DELMORE

STORMWATER INFRASTRUCTURE

Vineway Ltd

Revision	Date	Originator	Checker	Approver	Description
A	17/12/2024	JDK	JDK	JDK	Draft
B	07/02/2025	JDK	RR	JDK	Substantive Application
C	10/02/2025	JDK	RR	JDK	Substantive Application
D	11/02/2025	JDK	RR	JDK	Substantive Application
E	18/02/2025	JDK	JDK	JDK	Substantive Application
F	02/07/2025	JDK	JDK	JDK	Substantive Application
G	18/12/2025	JDK	LV	JDK	Substantive Application
H	22/12/25	JDK	JDK	JDK	Substantive Application
I	10/05/2026	JDK	LV	JDK	Substantive Application
J	26/05/2026	JDK	LV	JDK	Substantive Application

Figure 18 - NZTA culver inlet, with flood levels annotated

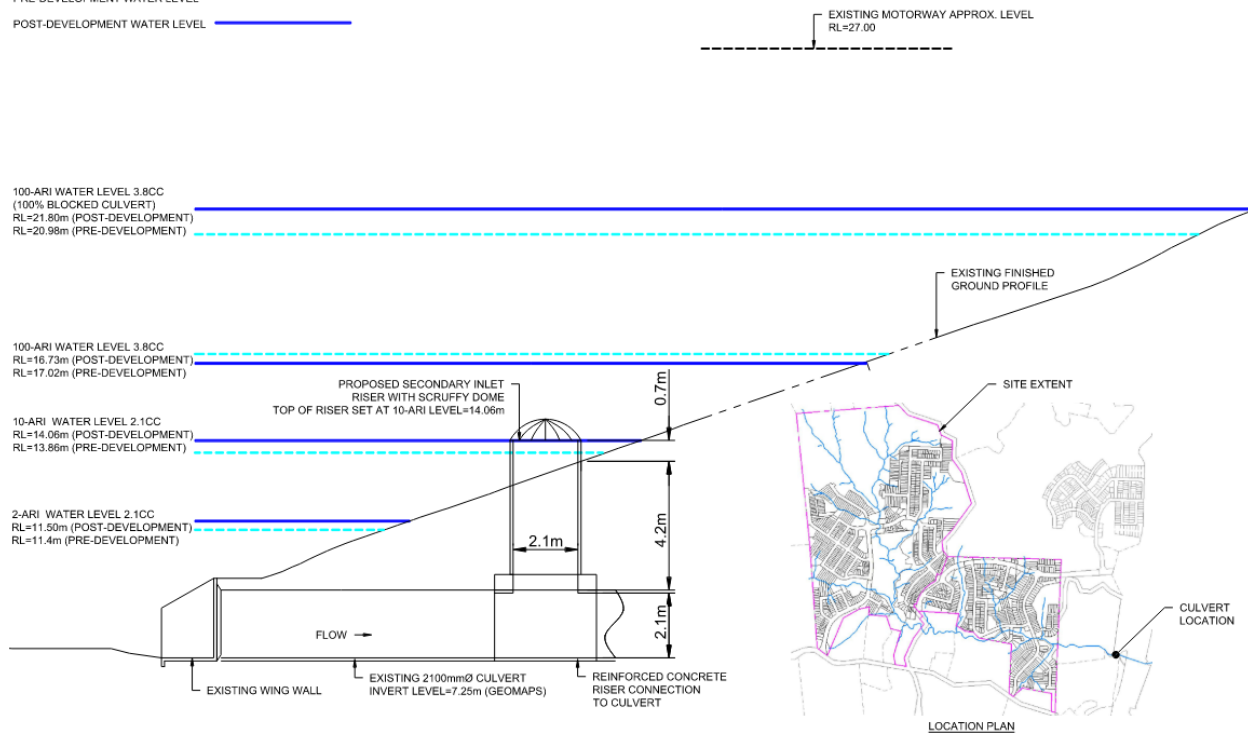
1. **Flood Risk Assessment – Habitable Floors.** Can HW please confirm that if an inlet riser is proposed to the NZTA culvert as per the attached drawing 3725-1-4815 that this comment would be closed out and there would be no additional stormwater modelling required. Pranil is going to contact NZTA this week and get confirmation with them that the principle of this idea is okay with them as well.

Healthy Waters queried the downstream effects of providing a secondary inlet, as this may increase flood flows.	Secondary inlet is now not proposed.
McKenzie will incorporate the supplementary culvert into the flood model.	As above.
Since the modelling is being undertaken in HEC RAS, it is recommended that the approach to representing the supplementary culvert is discussed and agreed with Healthy Waters (Larry) in advance.	As above. A meeting with Larry has been requested, however this is not available until January 2026.
Healthy Waters will issue a response to the flood comments and provide a response to parks.	No action.
Other matters	
Culverts in wetlands discussed, namely the incision of existing wetlands and wetlands being established inside the culverts. Contrary to geotech/geomorphic reporting	No action
Hydrology reporting to be provided for the wetlands – McKenzie to provide flows / velocity etc	The culvert drawings including this information can be found in drawings series 3725-1-4800.

The inlet with flood levels shown relative to the inlet and top of embankment for pre and post development flows are shown in Figure 18. All lots are set above the 100% blocked, MPD with climate change scenario, to protect from inundation.
